# Service Bulletin

Bulletin No.: 19-NA-032

**Subject: Lack of Power and/or Hesitation After Vehicle Has Reached Operating Temperature, Malfunction Indicator Lamp (MIL) Illuminated - DTC P0325 and/or P0330 May Set**

Brand:	Model:	Model Year:		VIN:		Engine:	Transmission:
		from	to	from	to		
Chevrolet	Malibu	2018	2018			1.5L (LFV)

5225807

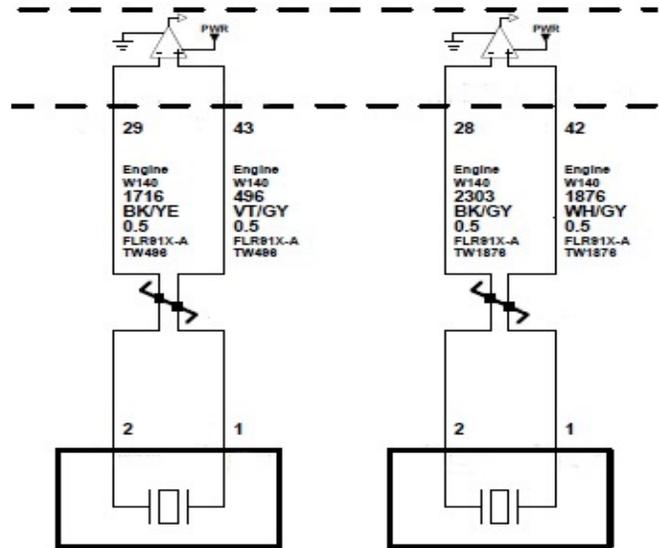
5. Locate cavity 28, 29, 42 and 43 at the X2 connector. Refer to Document ID#: 5067630.

5225787

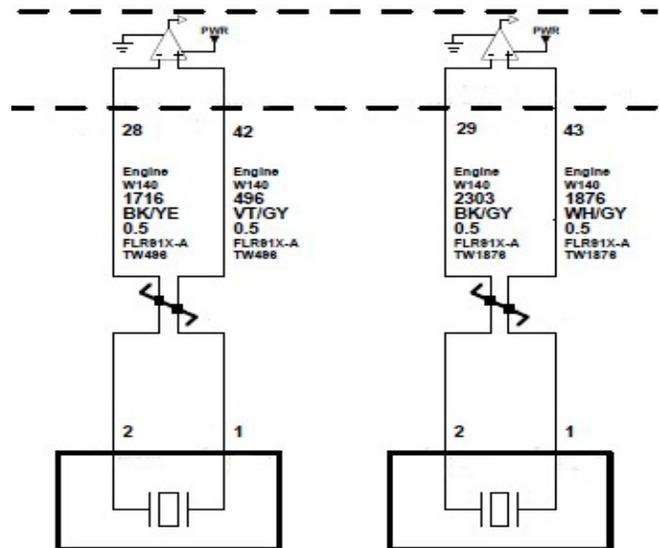
6. Verify the following:
  - Cavity 28, BK/GY
  - Cavity 29, BK/YE
  - Cavity 42, WH/GY
  - Cavity 43, VT/GY
7. Remove pin 28 and pin 29.
8. Insert pin 28 into cavity 29 and pin 29 into cavity 28.
9. Remove pin 42 and pin 43.
10. Insert pin 42 into cavity 43 and pin 43 into cavity 42.

11. Verify the pins are in the new cavity as listed below:
  - Cavity 28, BK/YE
  - Cavity 29, BK/GY
  - Cavity 42, VT/GY
  - Cavity 43, WH/GY
